SERVICE BULLETIN

APPLICABILITY: 2014MY Forester

NUMBER: 12-163-14

SUBJECT: Revised Sunroof Deflector for Rattling Sound

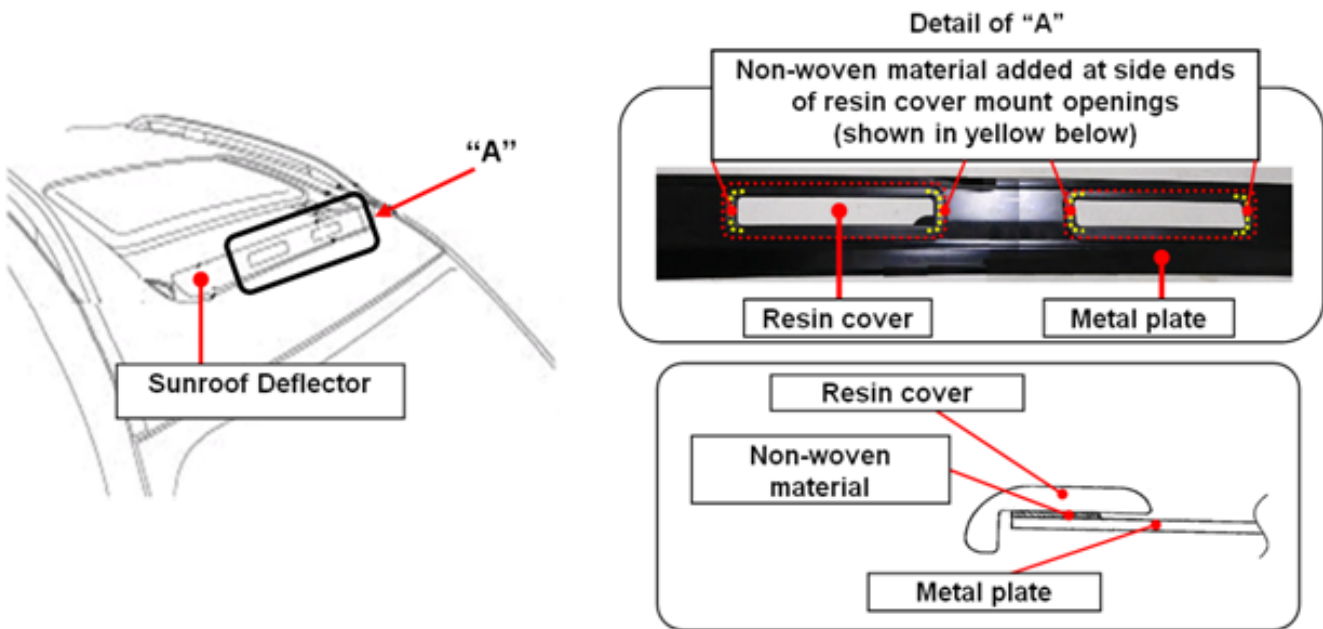
If you receive a customer concern of a rattling sound from the sunroof air deflector while driving with the roof panel closed, a countermeasure part has been developed to eliminate it. Non-woven material has been added to the resin cover portions of the air deflector as shown in the illustration below.

The new air deflector was incorporated into production during August, 2013 starting with VIN E*486792.

PART NAME	PART NUMBER
Deflector ASSY -- Sunroof	65471SG001
